Planning and Zoning Commission

February 5, 2019

Dallas Center – Grimes Middle School – Site Plan

FOX Engineering has completed the second review for the DC-G Middle School Site Plan dated January 29, 2019. Please address the following comments:

REVISIONS:
01/09/19 1ST CITY SET
01/29/19 2ND CITY SET

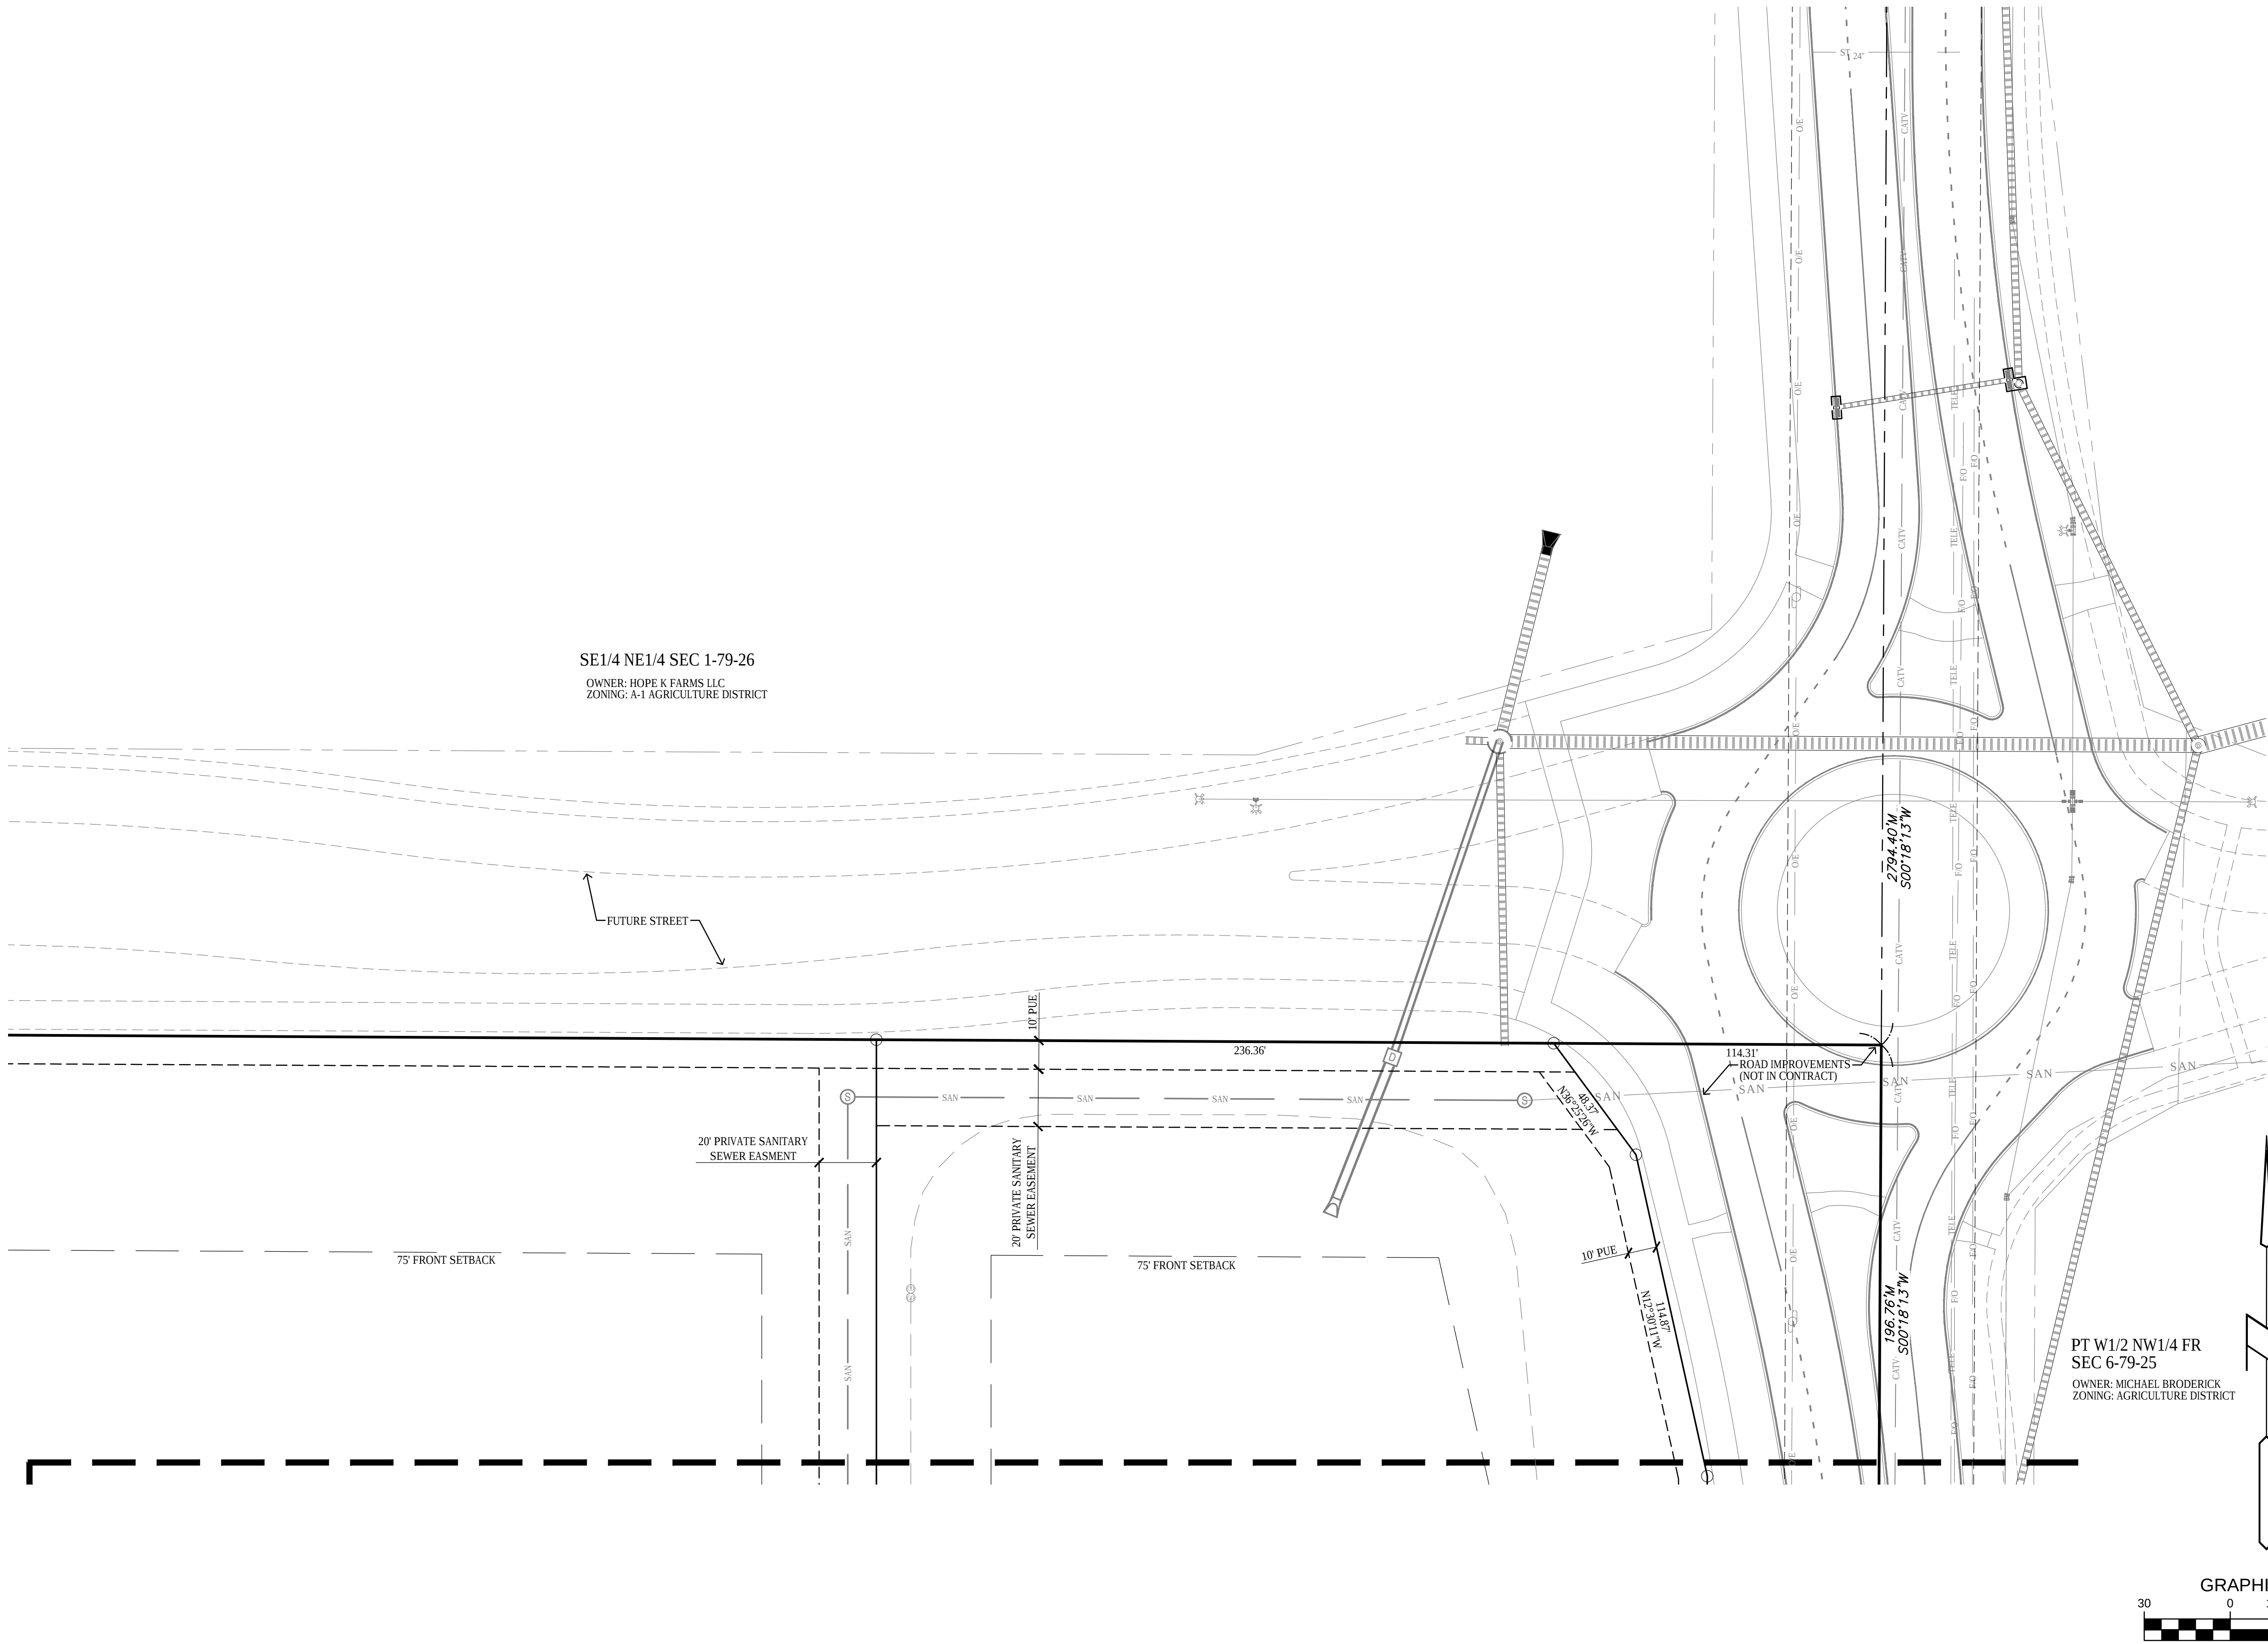
6. Please provide building dimensions around the courtyards on the site plan.

Utility Plan – Sheet C-401

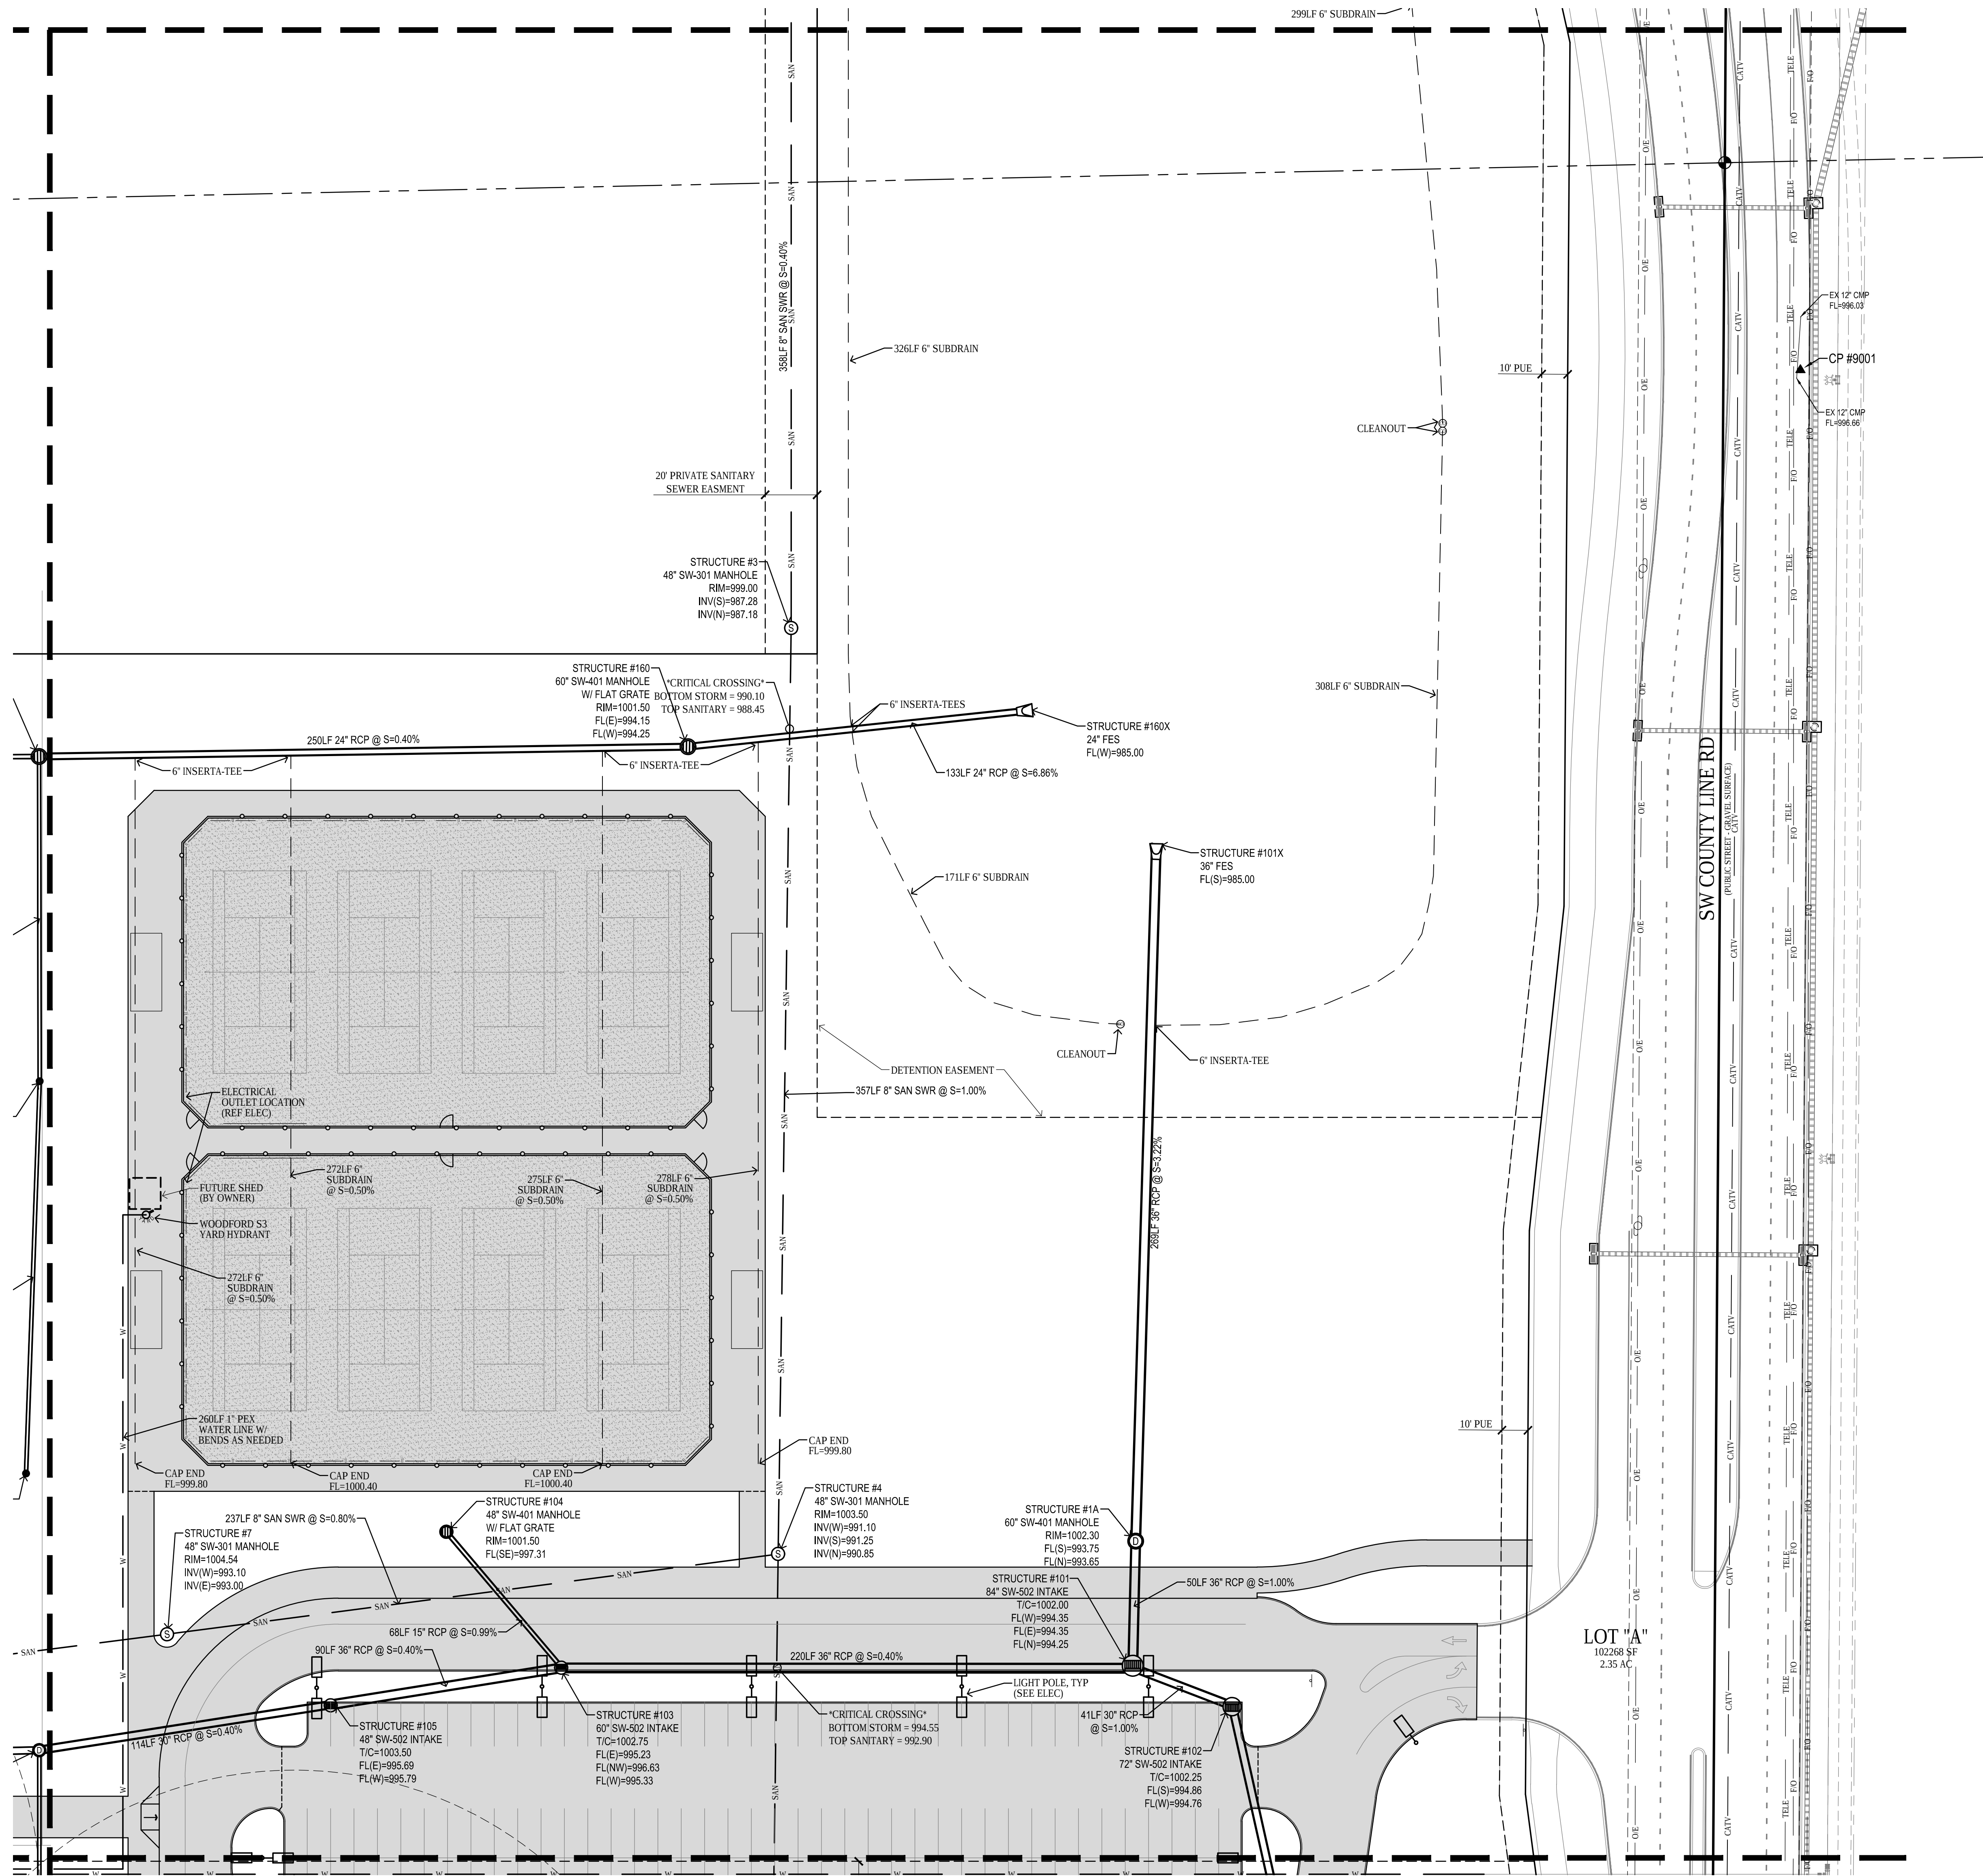
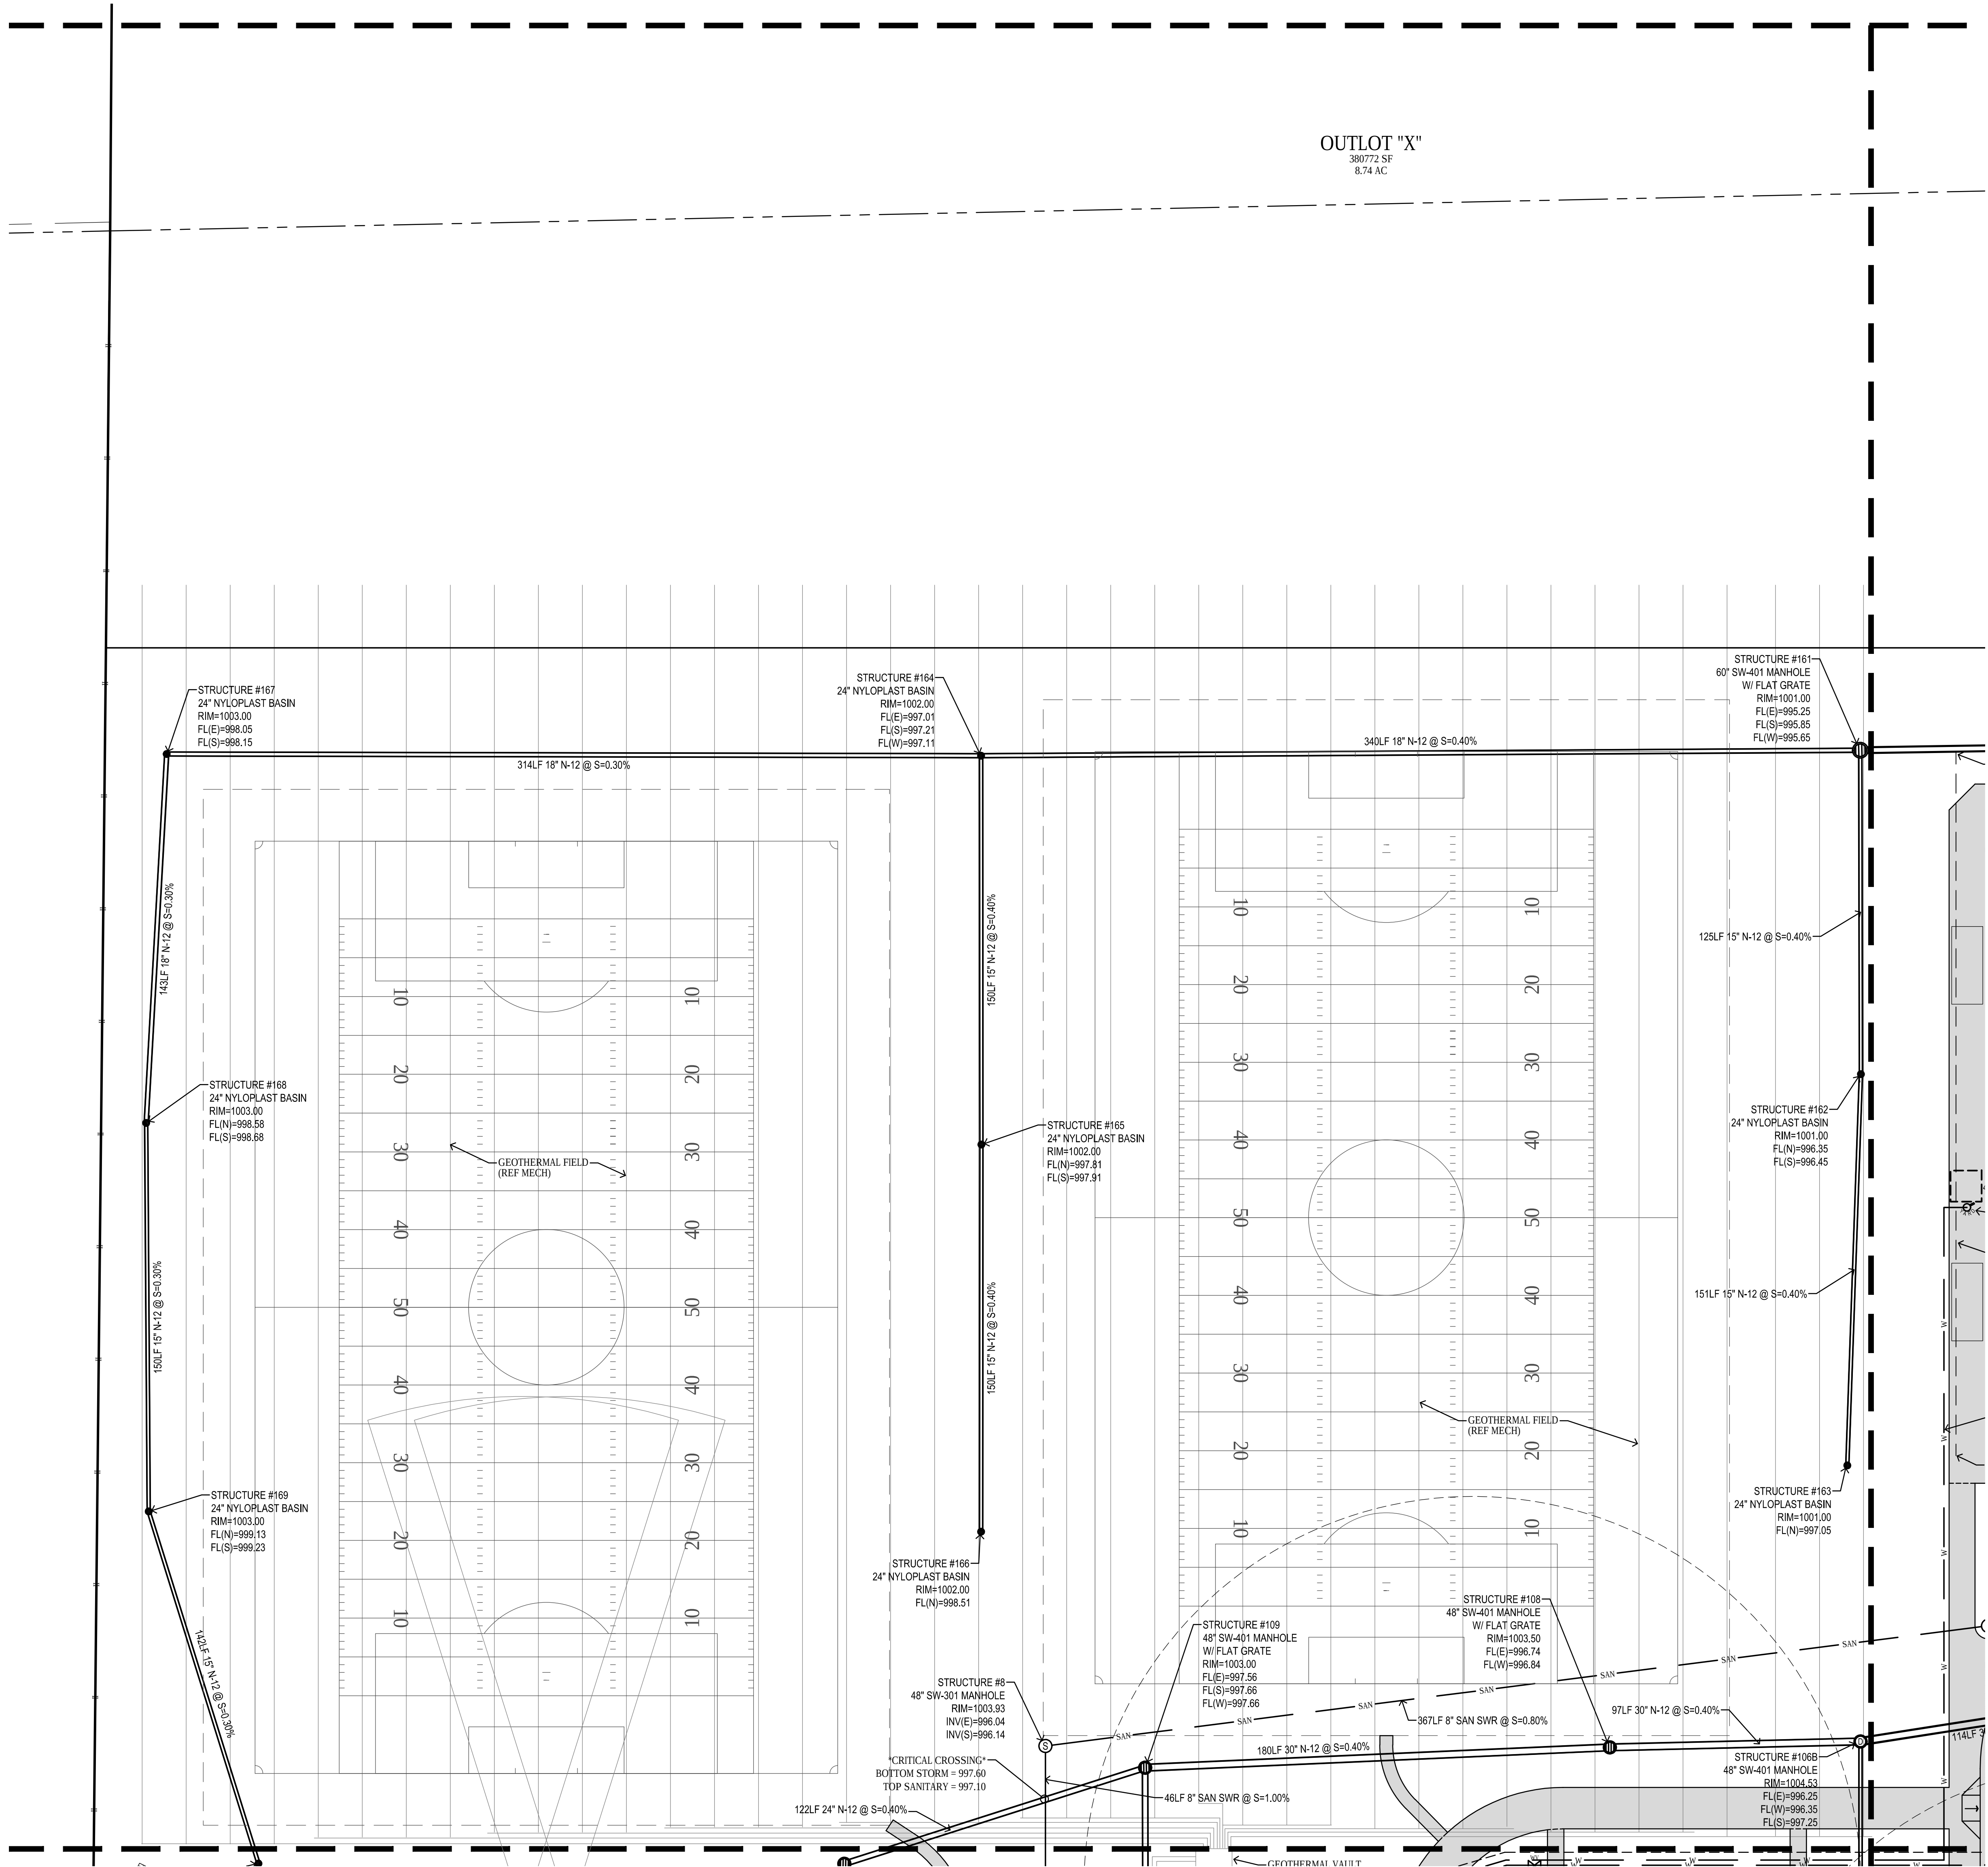
7. Please dimension between the fire department connection and nearest hydrant to verify they are within 100-ft of each other.
